**Kronospan**

Schedule 5 Response No 3

**Site Plan**  
Areas Of Environmental Responsibility  
7000/282

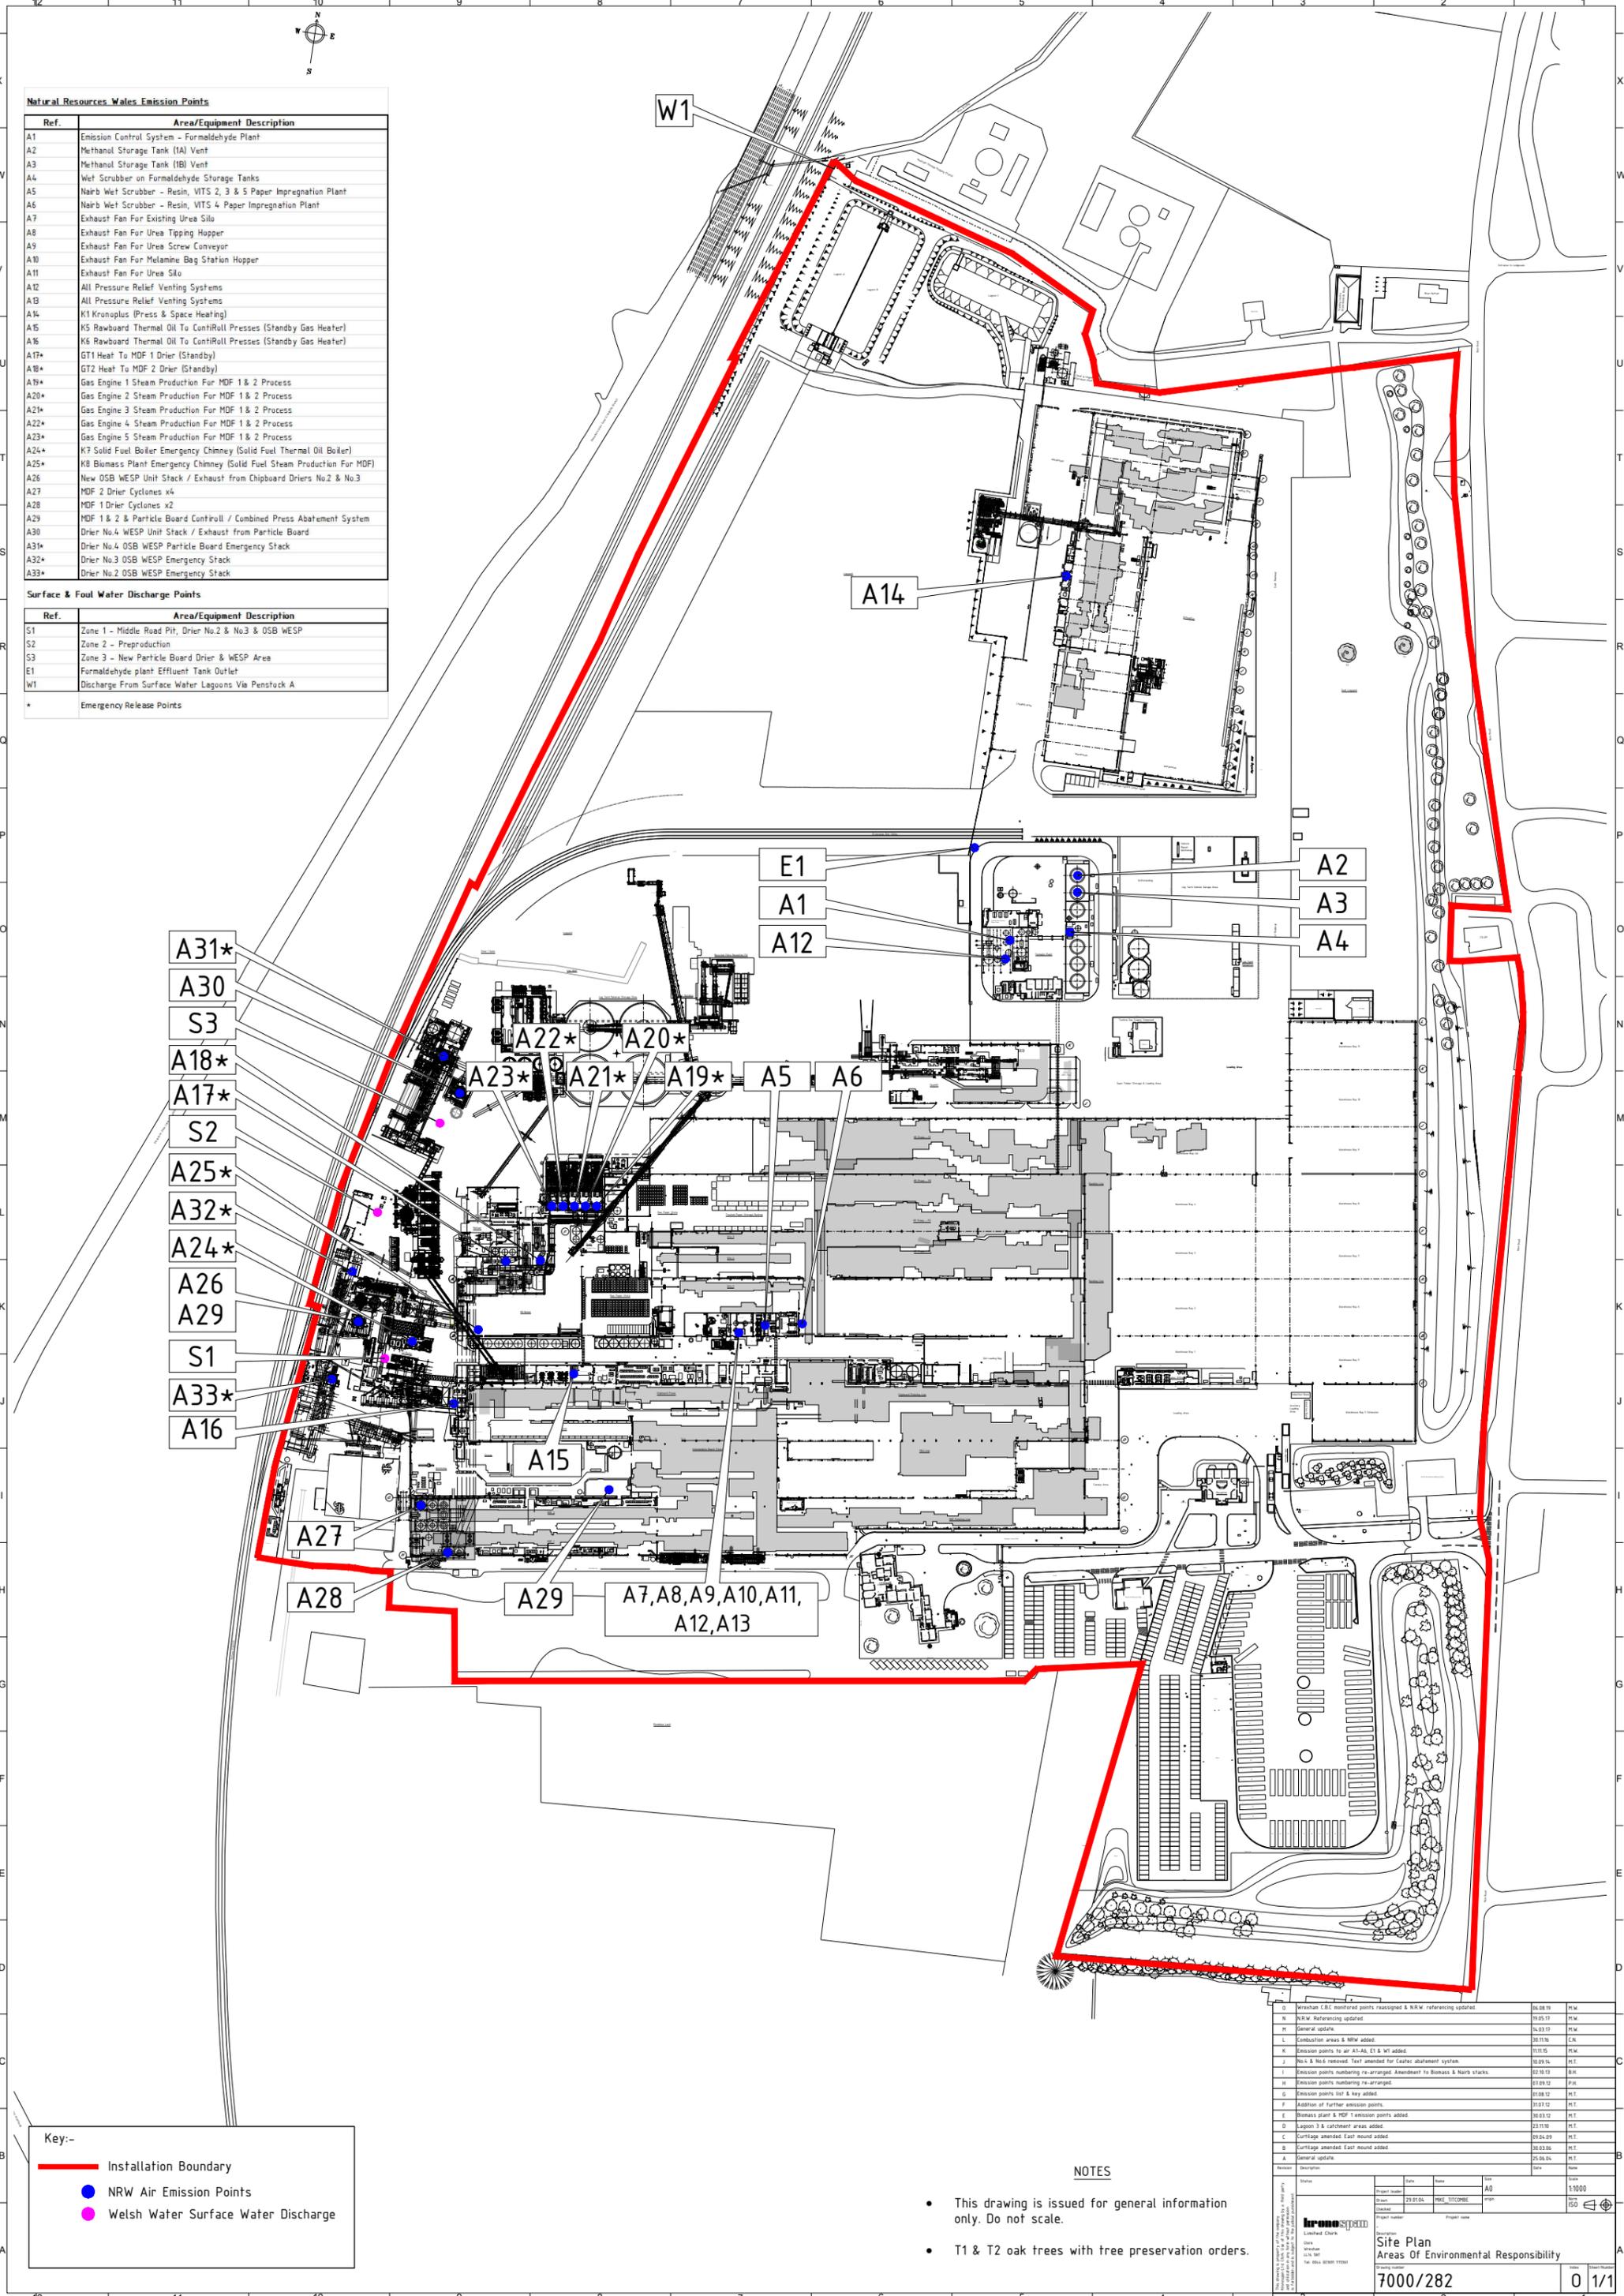
*The current site plan attached to the NRW permit shows the emission points on site, which are grouped and numbered according to regulator. Regulation of the whole site will switch to NRW as the single environmental regulator following the Welsh Government Direction published in March 2018. Please revise the site plan so that it matches this future scenario as follows:*

- i) Please remove the green shaded blocks from the plan as these denote discrete areas of the site previously regulated by NRW.*
- ii) In terms of the following emission points to air, the following numbering is suggested, which will match with the existing emission point numbering in the NRW permit:*

*However, these emission point names shall also be updated to account for the new Particleboard WESP (which needs to be included as a new emission point) and changes to the press abatement release through the original Particleboard WESP. It is understood that “MDF1, MDF2 and Particleboard Controll combined” is now an emergency release point only and shall be included as such. In addition, the updated site plan shall include the new emission point associated with Chip Dryer 4.*

The emission point numbering has been amended on the site plan as requested. Kronospan has also reviewed the current emission points and have removed 2 points which do not release to
